BLUE MARSH LAKE,

Bernville Protective Works.

DESIGN MEMORANDUM NO. 13

JAN. 1975

D.M. NO. 13 PLATE 7

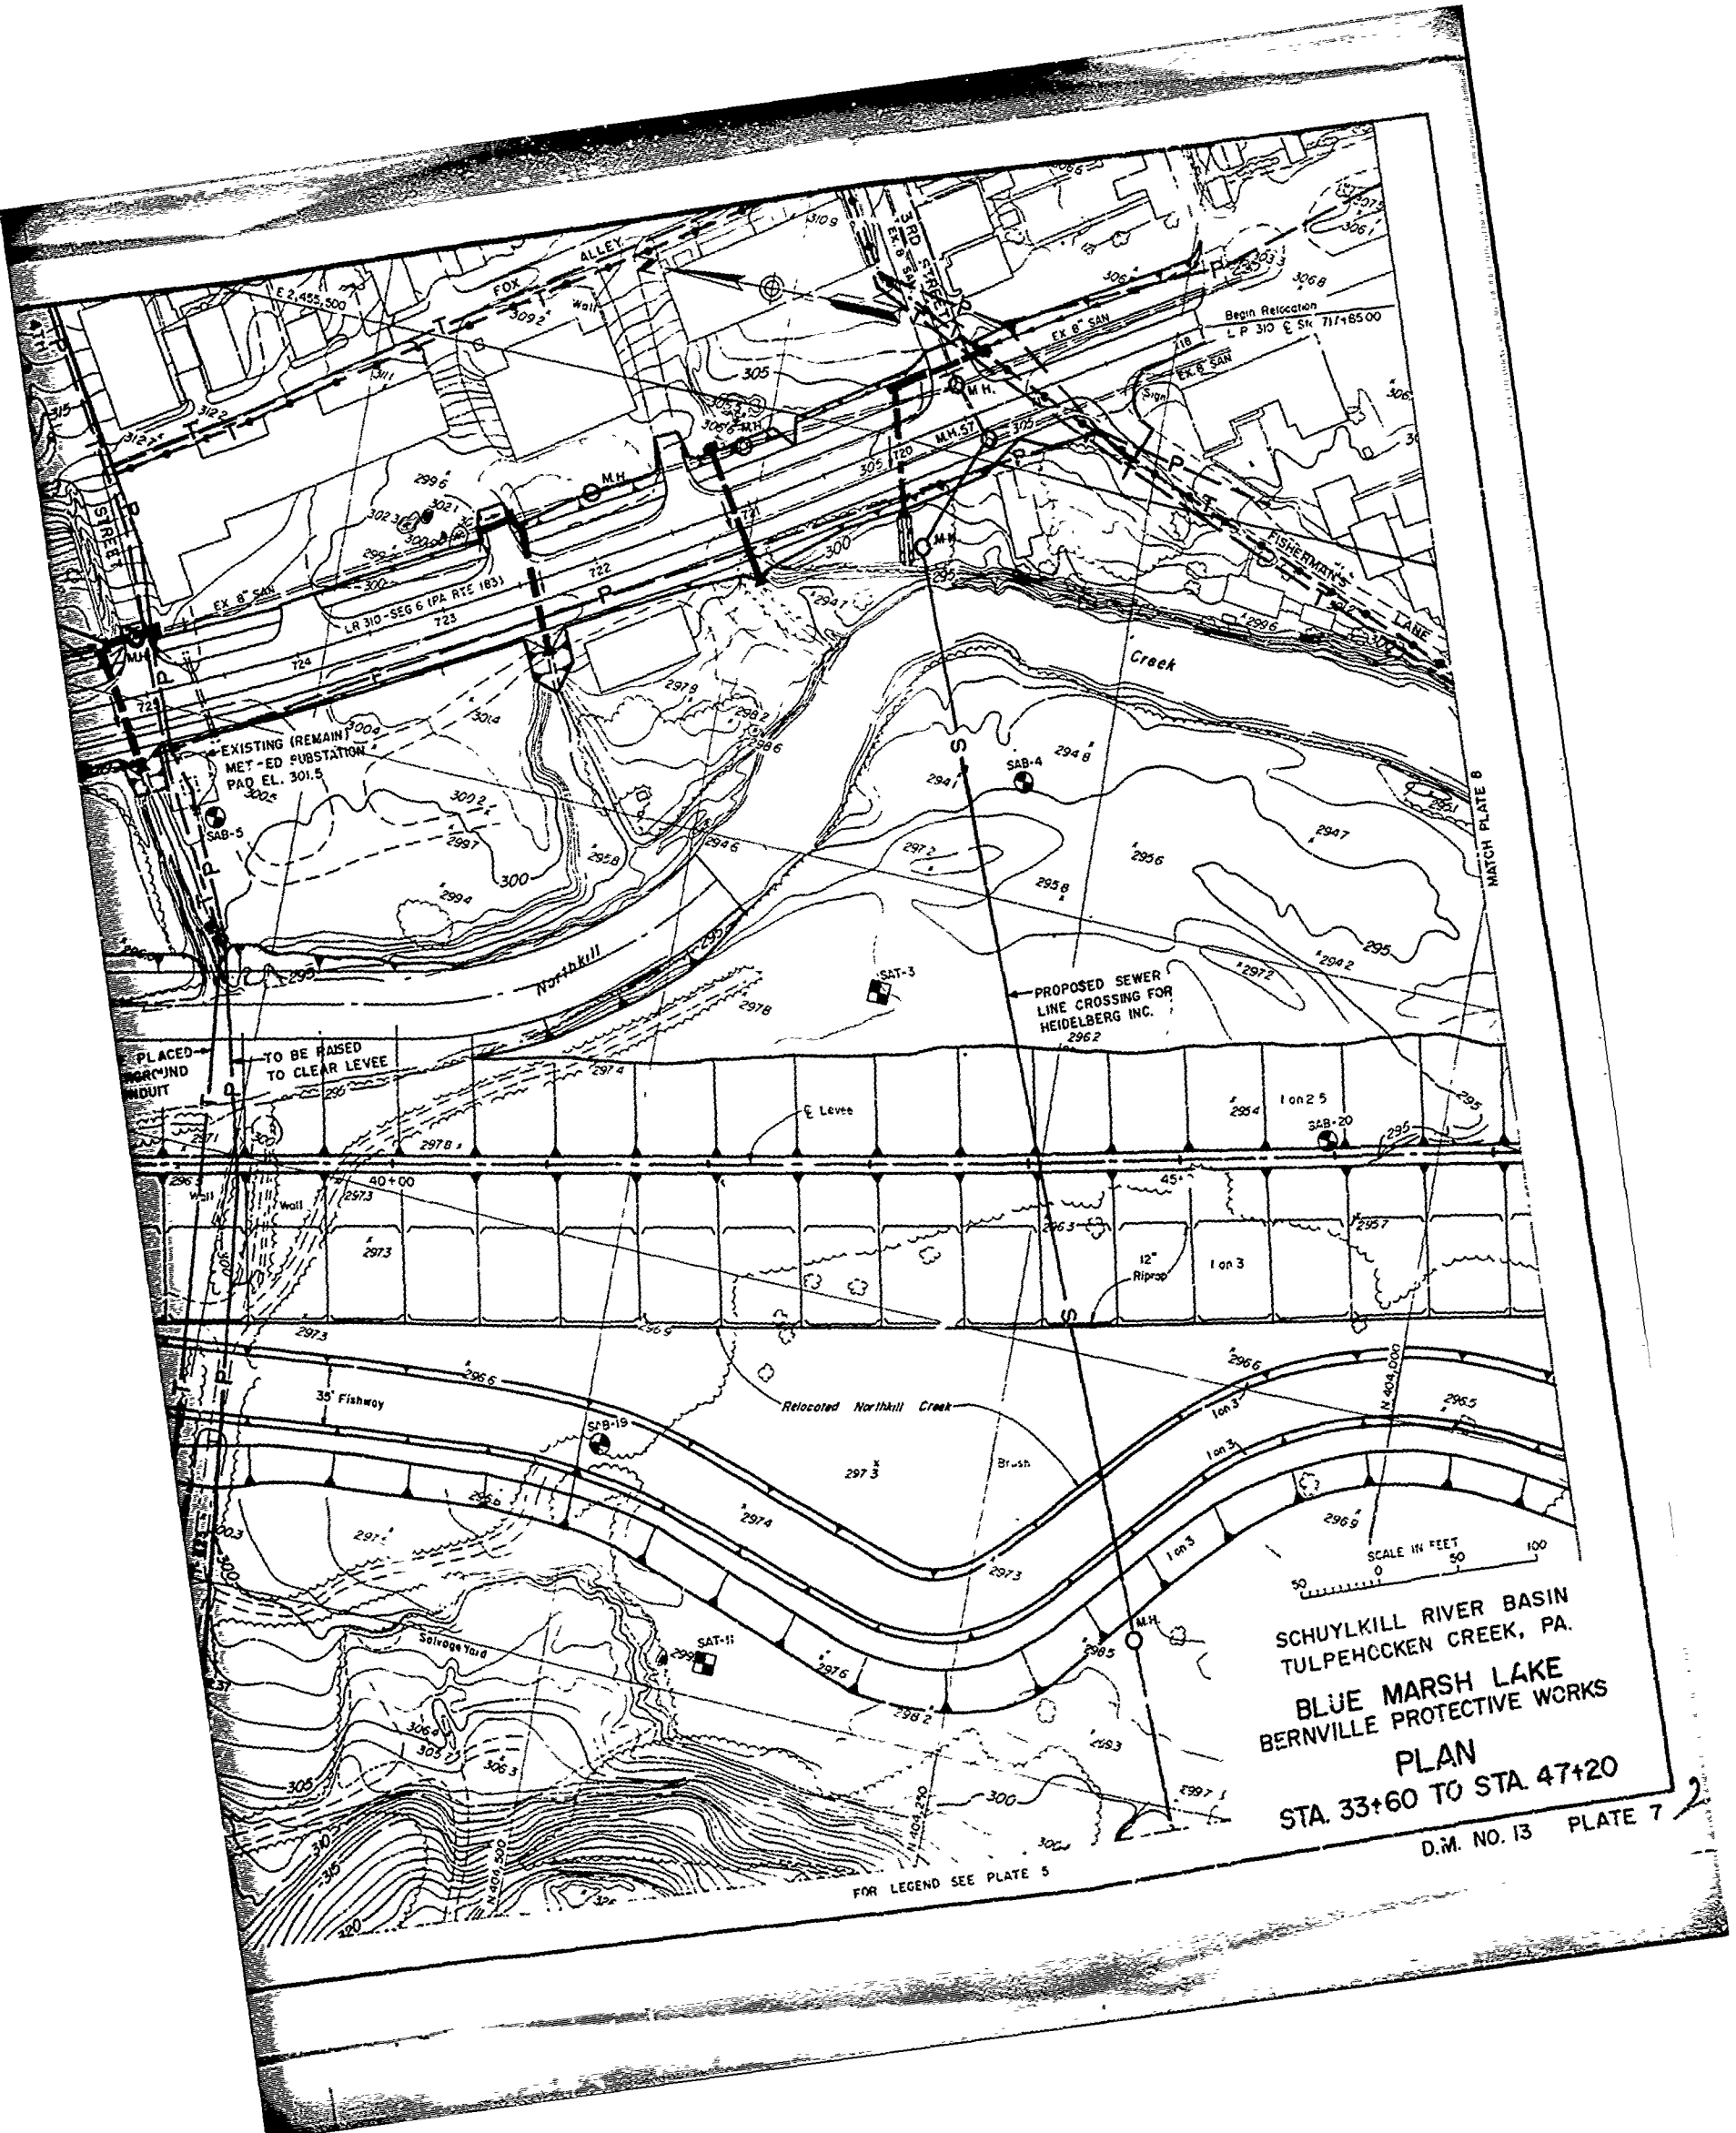
(2) Plate 7. It will be necessary to relocate about 300 feet of pole line to avoid the access road to the top of the dike from the pumping plant. The pole line extending west from LR 310 across the levee and Northkill Creek to LR 06020 is to be abandoned. This abandonment is covered in DM 12, Part II, Utility Relocations.
